**ZONING AMENDMENT,  
PLANNED UNIT DEVELOPMENT &  
PLANNING APPROVAL STAFF REPORT**

**Date: April 21, 2011**

<b><u>NAME</u></b>	MAWSS Stickney Plant
<b><u>LOCATION</u></b>	4800 and 4900 Moffett Road (Northwest corner of Moffett Road and Shelton Beach Road Extension)
<b><u>CITY COUNCIL DISTRICT</u></b>	District 1
<b><u>PRESENT ZONING</u></b>	R-1, Single-Family Residential and B-2, Buffer Business
<b><u>PROPOSED ZONING</u></b>	R-1, Single-Family Residential
<b><u>REASON FOR REZONING</u></b>	To correct a split-zoning condition
<b><u>AREA OF PROPERTY</u></b>	41.3 $\pm$ Acres (PUD and Planning Approval site) 0.2 $\pm$ Acres (Zoning site)
<b><u>CONTEMPLATED USE</u></b>	<p>Planning Approval to allow the operation of a water treatment plant in an R-1, Single-Family Residential District, Planned Unit Development Approval to allow the addition on a bulk silo at a water treatment facility with multiple buildings on a single building site, and Rezoning from B-2, Neighborhood Business District, to R-1, Single-Family Residential District to eliminate split zoning and allow the operation of a water treatment plant.</p> <p><b>It should be noted, however, that any use permitted in the proposed di

# SITE PLAN

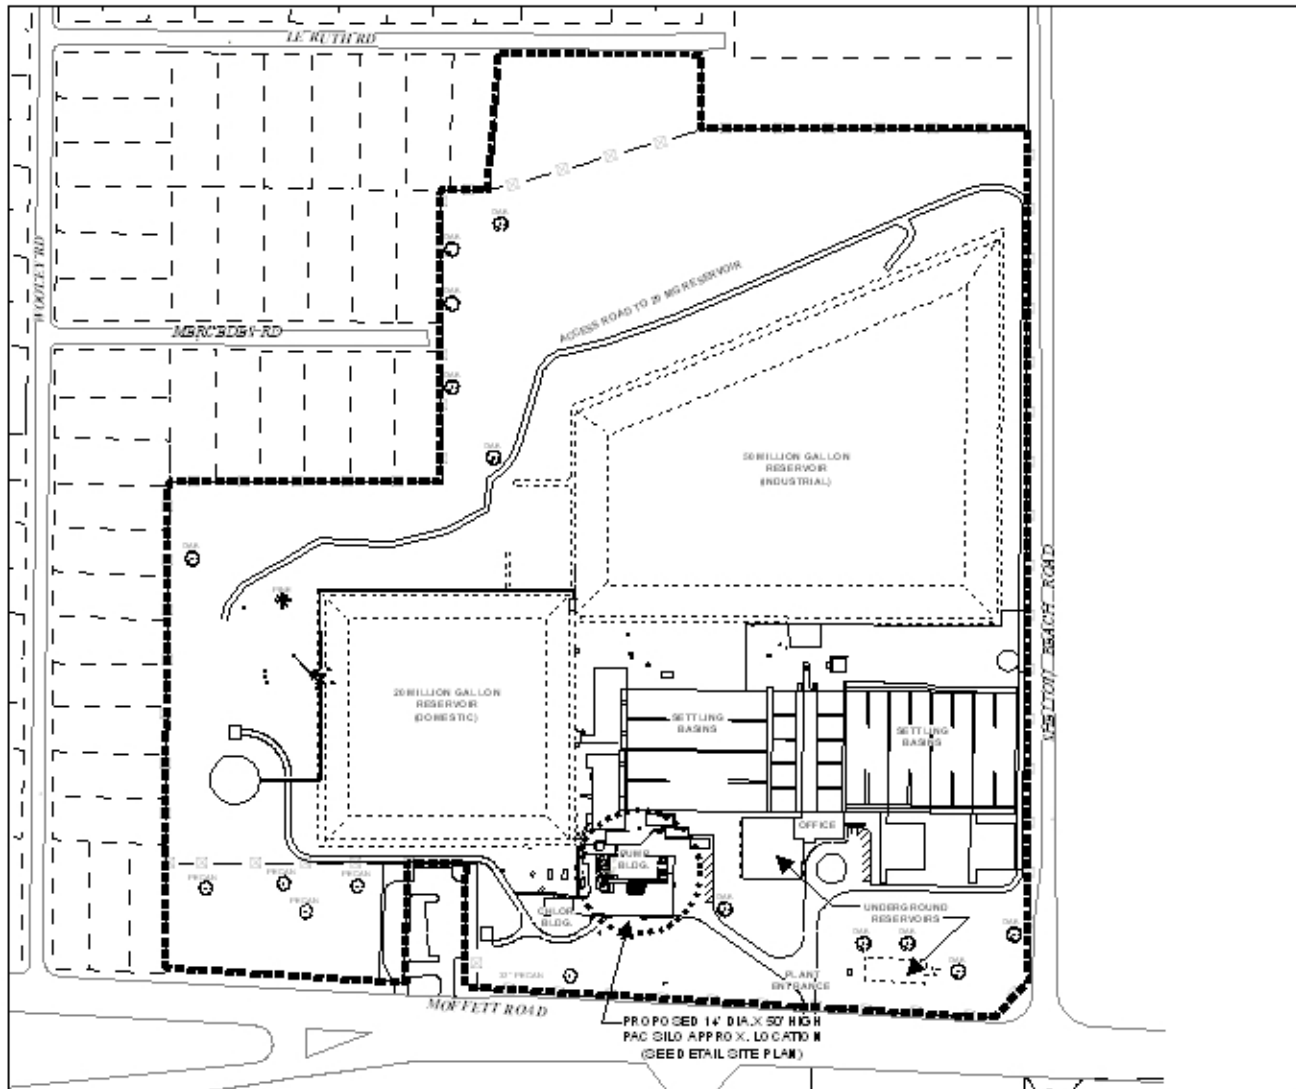
It should also be pointed out that a lot to the West of the site shown on the submitted site plan should also be included (Lot 7, Block 3, Forest Heights), as it is owned by MAWSS, and there appears to be access to the main site via a dirt drive to Woodley Road. The lot does not need to be included in any Subdivision application, but should be depicted on the PUD and Planning Approval site plans.

The site fronts onto Moffett Road, a proposed major street with adequate right-of-way, and Shelton Beach Road Extension, a minor street with adequate right-of-way. The site has one paved entrance on Moffett Road, and one unpaved entrance on Shelton Beach Road Extension: these two entrances are gated. A third unpaved entrance may exist, as previously mentioned, from Woodley Road, however, this is not shown on the site plan. The site plan should be revised to include the property fronting onto Woodley Road (Lot 7, Block 3, Forest Heights), and indicate if there is fencing or access via this property.

The site plan also does not appear to depict the recently added telecommunications tower, which was approved by the Board of Zoning Adjustment at its November 2, 2009 meeting. The site plan should be revised to depict the tower location.

Finally, while the water treatment plant has been at this location a long time, perhaps longer than the adjacent residences, a buffer fence or vegetative buffer would typically be required where the site abuts the residences to the West and Northwest of the site. It is recommended that the applicant provide a 6-foot high wooden privacy fence along its Western and Northwestern boundaries where the site abuts residences, only where there is no existing privacy fence. Where the site is heavily vegetated on the Northern-most portion, no privacy fence should be required. Any existing security fencing should remain around the perimeter of the site, however, it should be noted that new barbed-wire, razor-wire or similar fencing should be approved by the Board of Zoning Adjustment, prior to placement with appropriate permits.

- 1) Revision of the site plan to include the adjacent lot (Lot 7, Block 3, Forest Heights);
- 2) Revision of the site plan to depict the recently constructed telecommunications tower;
- 3) Placement of a note on the site plan stating that the removal of any 24-inch and larger diameter tree depicted on the site plan shall be coordinated with Urban Forestry;

- 4) Depiction and provision of a 6-foot high wooden privacy fence where the site abuts existing single-family residences, where there is no existing privacy fence – existing security fencing to remain;
- 5) Any new barbed-wire, razor-wire or similar security fencing to be approved via a successful application to the Board of Zoning Adjustment prior to placement; and
- 6) Application for Subdivision approval (and Sidewalk Waiver, if desired) by the end of October 2011.
